Comments on 802.3ab D1.1

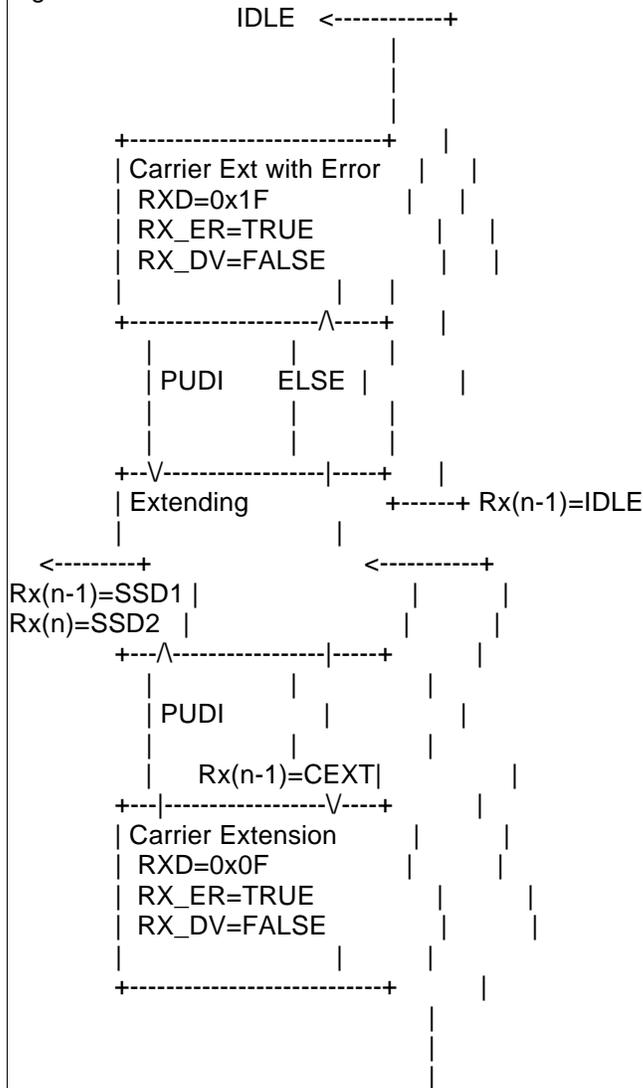
ID	44
Commentor	Creigh
Comment Type	t
Section	40.4.5.2
Page	40-38
Line	1-50
Comment	<p>The condition: (tx_enabe=FALSE)&(tx_error=TRUE)&(TXD!=0x0F)&(TXD!=0x1F) is not covered from several states of the PCS Transmit State Diagram. Specifically, "ERROR CHECK", "1st CSExtend VECTOR", "2nd CSExtend VECTOR", and "ESD1 VECTOR with Extend" do not cover this case and should have an exit to the appropriate left most column of states.</p> <p>Additionally, the states "1stCSExtend_Err VECTOR", "2nd CSExtend_Err VECTOR", and "1st ESD_Ext_Err VECTOR" have an exit on tx_error=TRUE that should be conditioned as: (tx_error=TRUE) & (TXD=0x0F TXD=0x1F)</p> <p>The exit tx_error=FALSE on these states should be conditioned as: (tx_error=FALSE) ((tx_error=TRUE)&(TXD!=0x0F)&(TXD!=0x1F))</p> <p>Additionally, the if statement in the "SEND IDLE/CARRIER EXTENSION" case should read:</p> <pre> if (tx_error=FALSE) ((tx_error=TRUE)&(TXD!=0x0F)&(TXD!=0x1F)) tx_symb_vector<=IDLE else if (TXD=0x0F) tx_symb_vector<=CEXT else if (TXD=0x1F) tx_symb_vector<=CEXT_Err </pre>

Response	Withdrawn
